South Texas Project Electric Generating Station 4000 Avenue F – Suite A Bay City, Texas 77414

August 10, 2009
U7-C-STP-NRC-090099

South Texas Project
Units 3 and 4
Docket Nos. 52-012 and 52-013
Response to Request for Additional Information

Attached are the responses to the NRC staff questions included in Request for Additional Information (RAI) letter numbers 147, 154 and 164 related to Combined License Application (COLA) Part 2, Tier 2, Chapter 16, Technical Specifications. This submittal completes the response to RAI letter numbers 147 and 154.

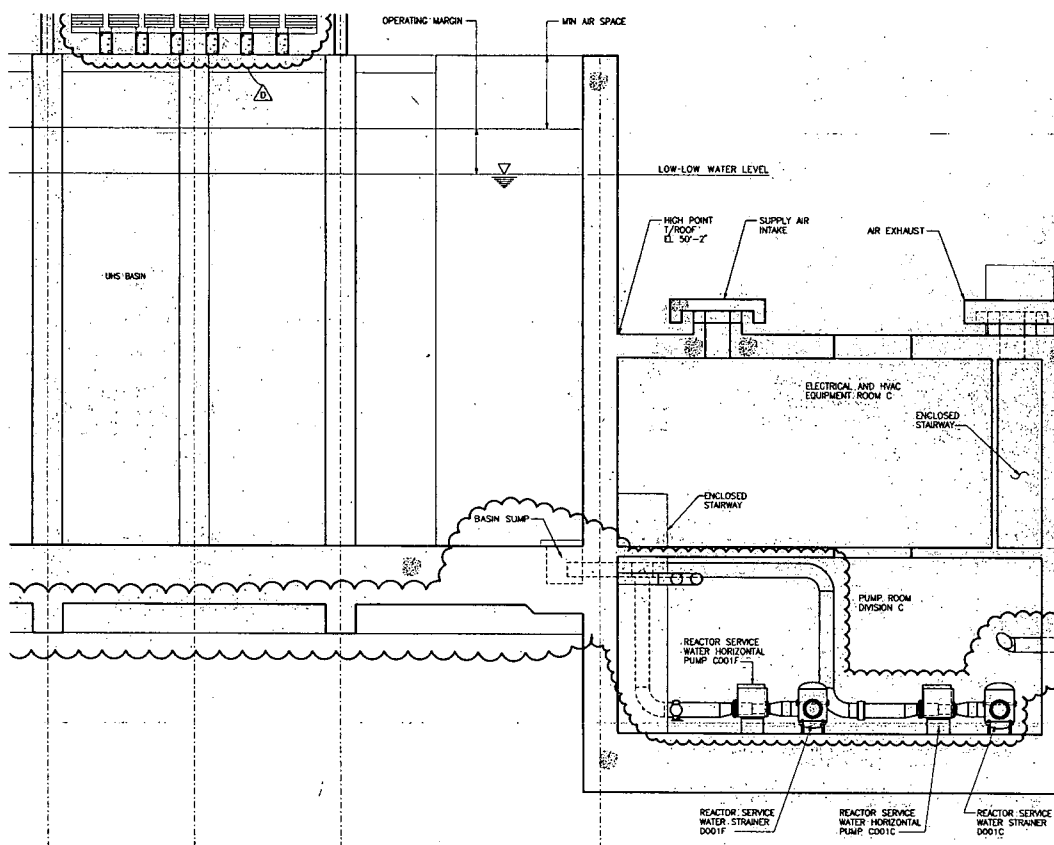
Revise SR 3.7.1.2 to verify the water level in the RSW pump well. Currently, PTS SR 3.7.1.1 and SR 3.7.1.2 require verification of the water level in the UHS basin. PTS SR 3.7.1.2 should correspond to GTS SR 3.7.1.2, requiring verification of the water level in the RSW pump well. Revise PTS SR 3.7.1.2 to require verification of RSW pump well water level.

The UHS and RSW system have been reconfigured as shown below. Part of the change includes the use of centrifugal type pumps rather than vertical wet-pit type pumps. As a result, conventional pump wells are not needed and are not designed into the system. Thus, the UHS basin water level must be measured in order to verify adequate water level for NPSH and vortex prevention considerations. Therefore, SRs 3.7.1.2, 3.7.2.2 and 3.7.3.2 were revised to verify water level in the UHS basin rather than in the pumps wells.

The UHS and RSW system have been redesigned to include the use of centrifugal type pumps located below the bottom of the UHS basin rather than vertical wet-pit type pumps located in pump wells. Thus, the UHS basin water level must be measured in order to verify adequate water level for NPSH and vortex prevention considerations. Therefore, SRs 3.7.1.2, 3.7.2.2 and 3.7.3.2 were revised to verify water level in the UHS basin rather than in the RSW pumps wells.

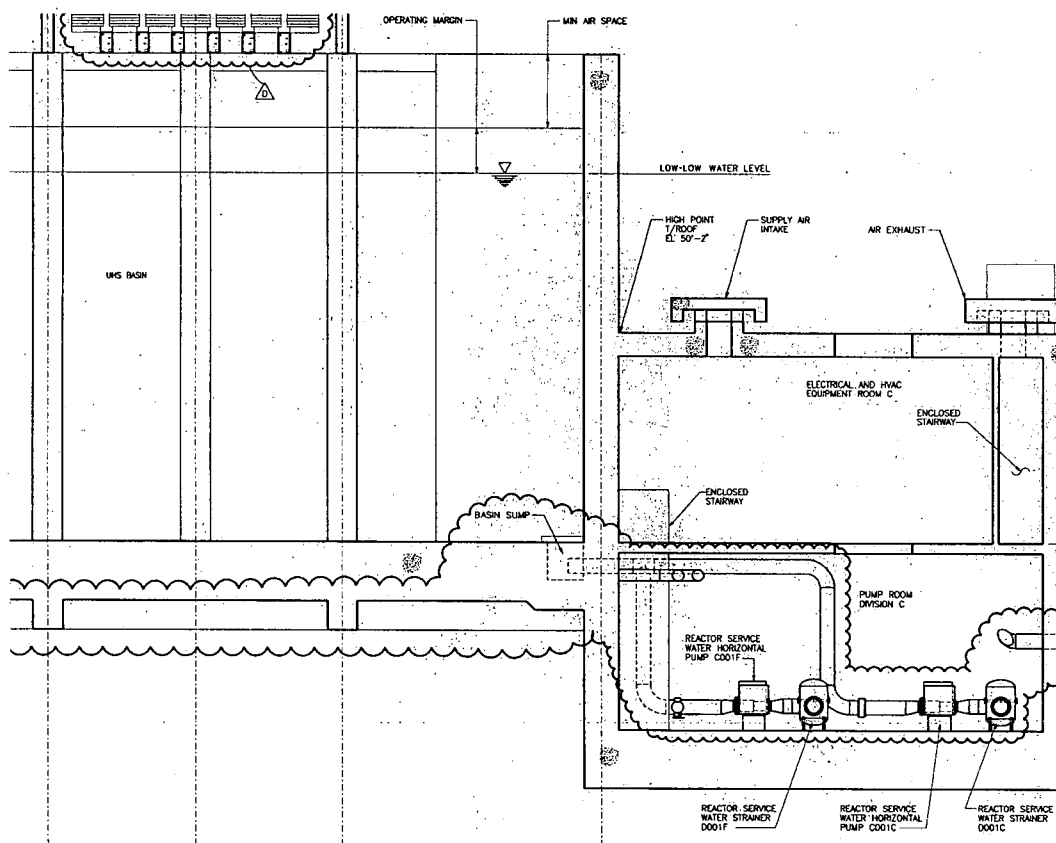
The applicant is requested to justify, in a STD DEP, replacing GTS SR 3.7.2.2, to verify the water level in the RSW pump well, with PTS SR 3.7.2.2, to verify the water level in the UHS basin.

The UHS and RSW system have been reconfigured as shown below. Part of the change includes the use of centrifugal type pumps rather than vertical wet-pit type pumps. As a result, conventional pump wells are not needed and are not designed into the system. Thus, the UHS basin water level must be measured in order to verify adequate water level for NPSH and vortex prevention considerations. Therefore, SRs 3.7.1.2, 3.7.2.2 and 3.7.3.2 were revised to verify water level in the UHS basin rather than in the pumps wells.

The UHS and RSW system have been redesigned to include the use of centrifugal type pumps located below the bottom of the UHS basin rather than vertical wet-pit type pumps located in pump wells. Thus, the UHS basin water level must be measured in order to verify adequate water level for NPSH and vortex prevention considerations. Therefore, SRs 3.7.1.2, 3.7.2.2 and 3.7.3.2 were revised to verify water level in the UHS basin rather than in the RSW pumps wells.

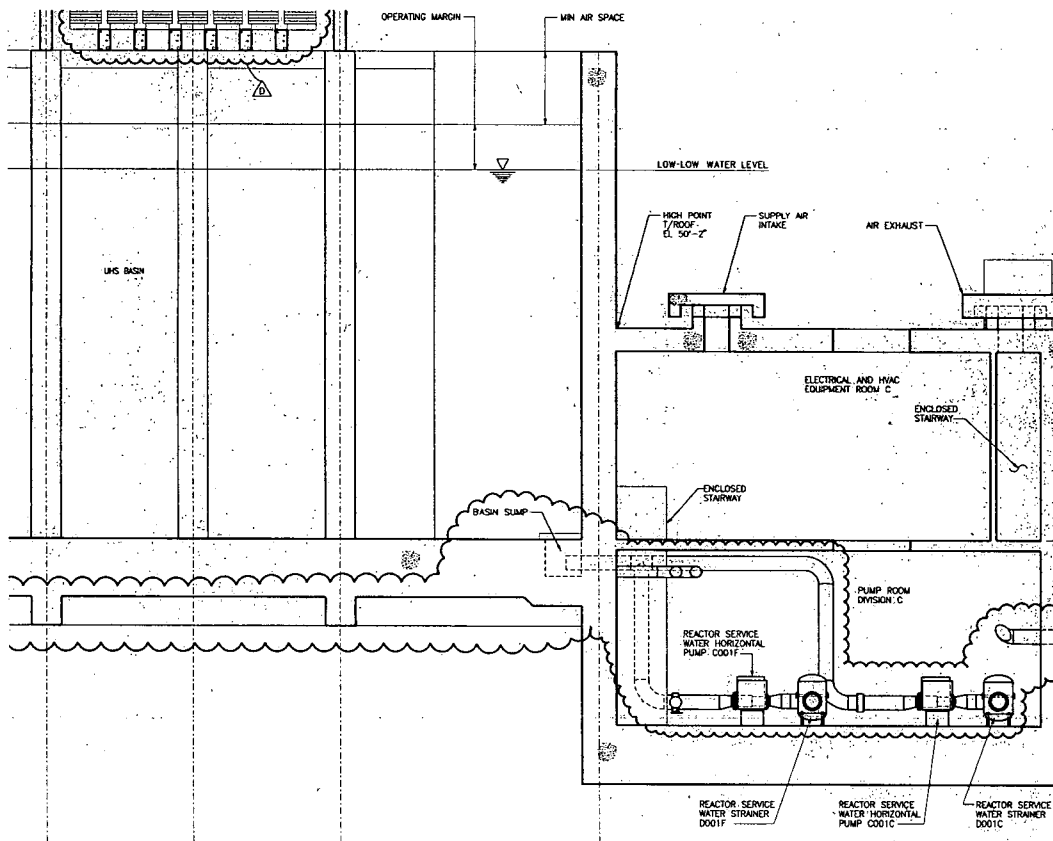
The applicant is requested to justify, in a STD DEP, replacing GTS SR 3.7.3.2, to verify the water level in the RSW pump well, with PTS SR 3.7.3.2, to verify the water level in the UHS basin.

The UHS and RSW system have been reconfigured as shown below. Part of the change includes the use of centrifugal type pumps rather than vertical wet-pit type pumps. As a result, conventional pump wells are not needed and are not designed into the system. Thus, the UHS basin water level must be measured in order to verify adequate water level for NPSH and vortex prevention considerations. Therefore, SRs 3.7.1.2, 3.7.2.2 and 3.7.3.2 were revised to verify water level in the UHS basin rather than in the pumps wells.

The UHS and RSW system have been redesigned to include the use of centrifugal type pumps located below the bottom of the UHS basin rather than vertical wet-pit type pumps located in pump wells. Thus, the UHS basin water level must be measured in order to verify adequate water level for NPSH and vortex prevention considerations. Therefore, SRs 3.7.1.2, 3.7.2.2 and 3.7.3.2 were revised to verify water level in the UHS basin rather than in the RSW pumps wells.
